Houston Lighting & Power

June 15, 1988  
ST-HL-AE-2683  
File No.: G9.1, R5  
10CFR50

South Texas Project Electric Generating Station  
Unit 2  
Docket Nos. STN 50-499  
Annotated FSAR Revisions Regarding  
the Revised Unit 2 Cycle 1  
Core Design/Energy Requirements

Attachment: Annotated Revisions to FSAR Chapters 1, 4 & 15  
and affected NRC Question Responses

Figure 15.4-12 A

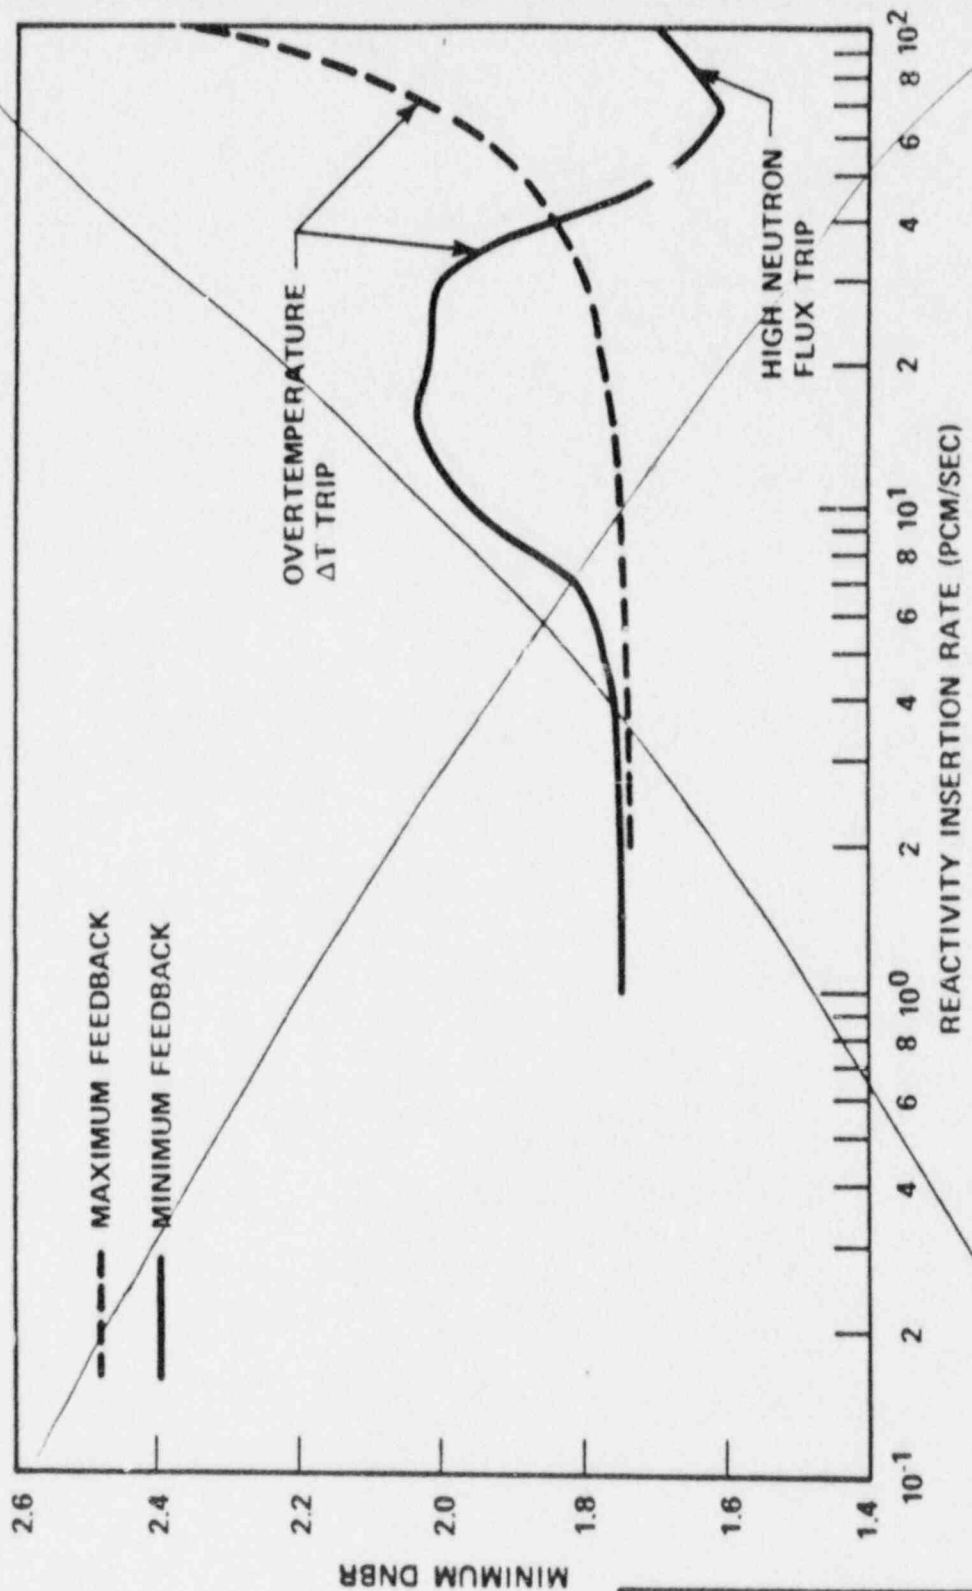
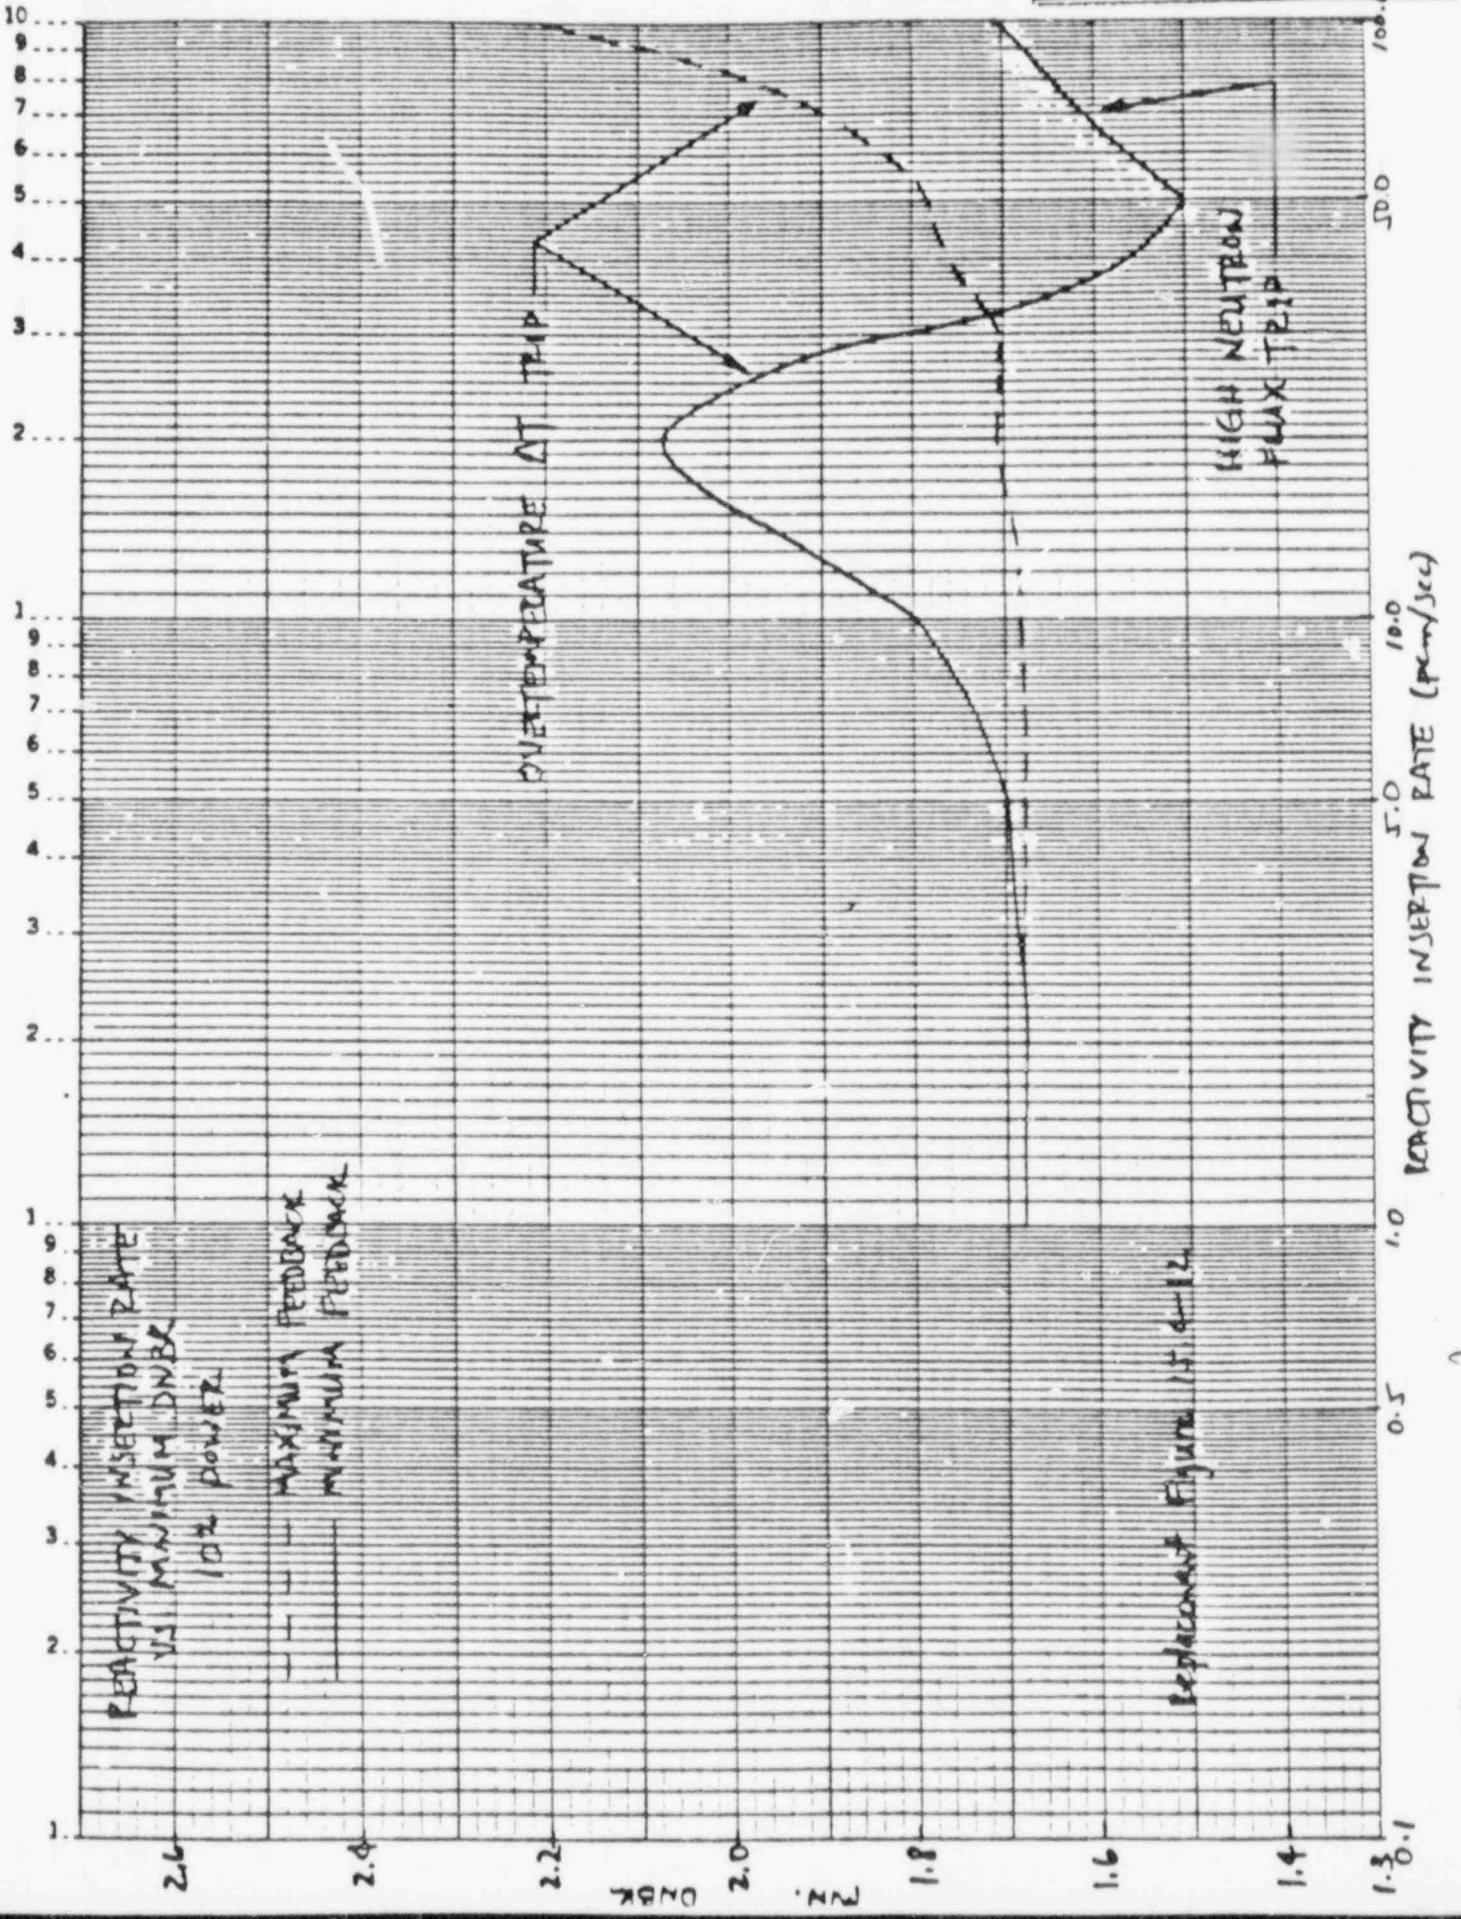
*Replace with following page*

Replacement Figure 15.4-12
